FirstEnergy

DESIGN VERIFICATION RECORD

Calc 3.2.15.14, Revision 0

Figure 15A.6-43

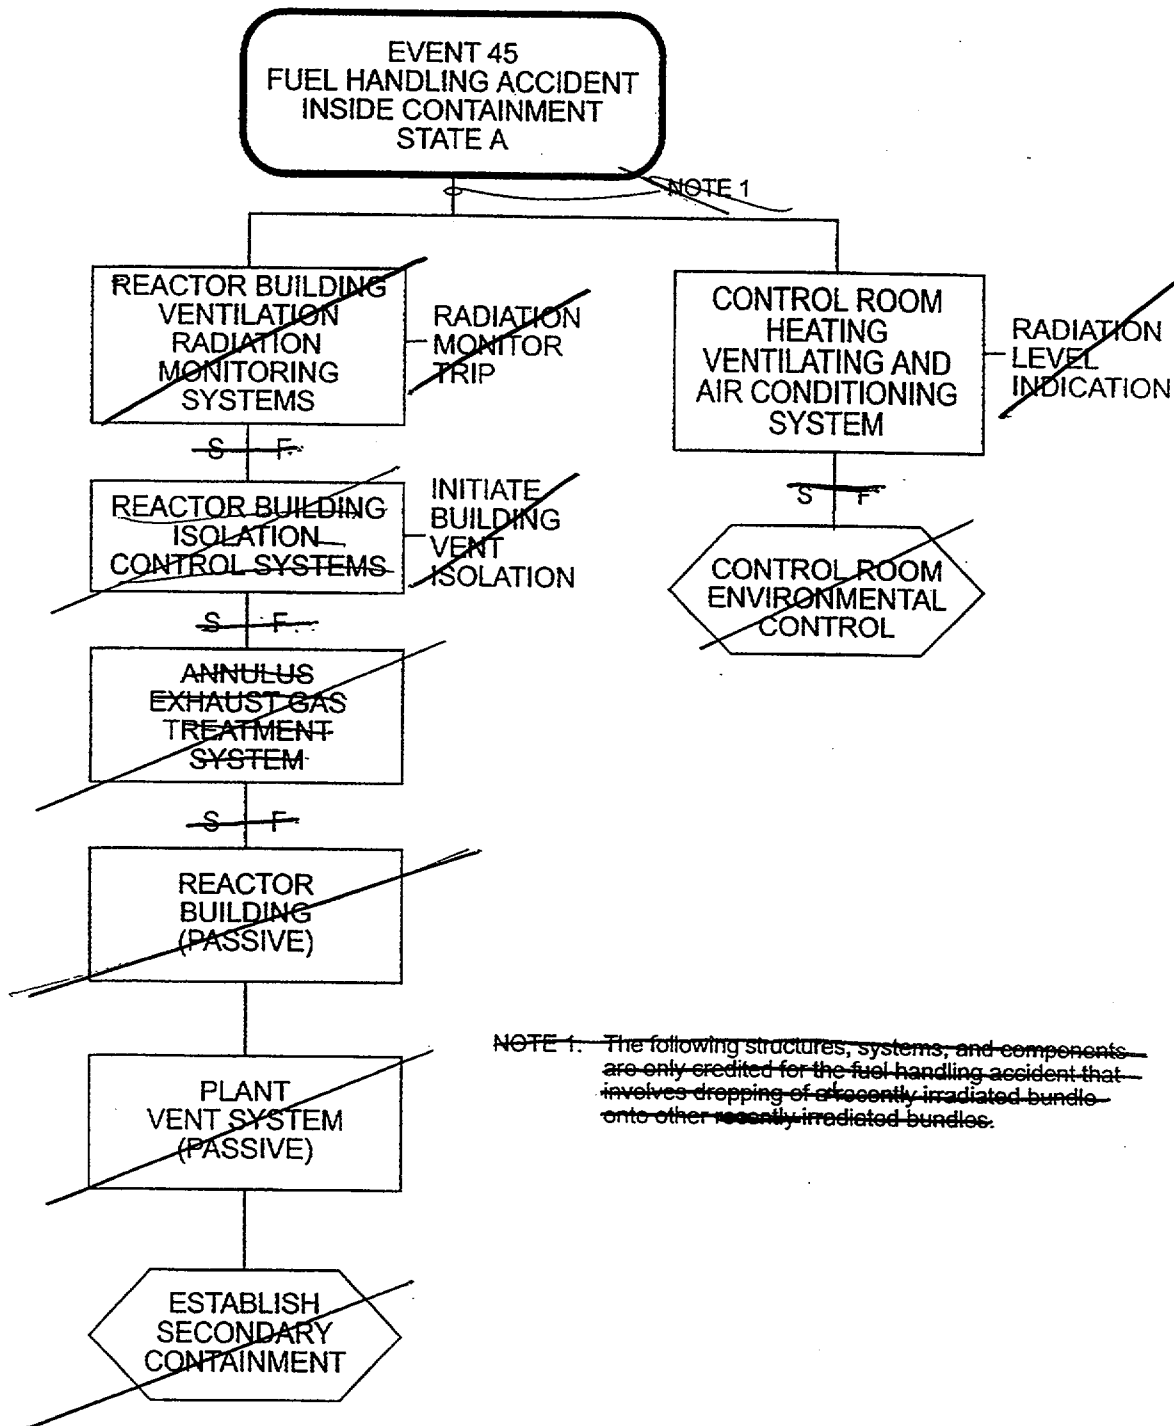
It is important to note that the systems, structures, and components described within Figure 15A.6-43 are only credited for the fuel handling accident that involves dropping of a ~~recently~~ irradiated bundle onto other ~~recently~~ irradiated bundles.
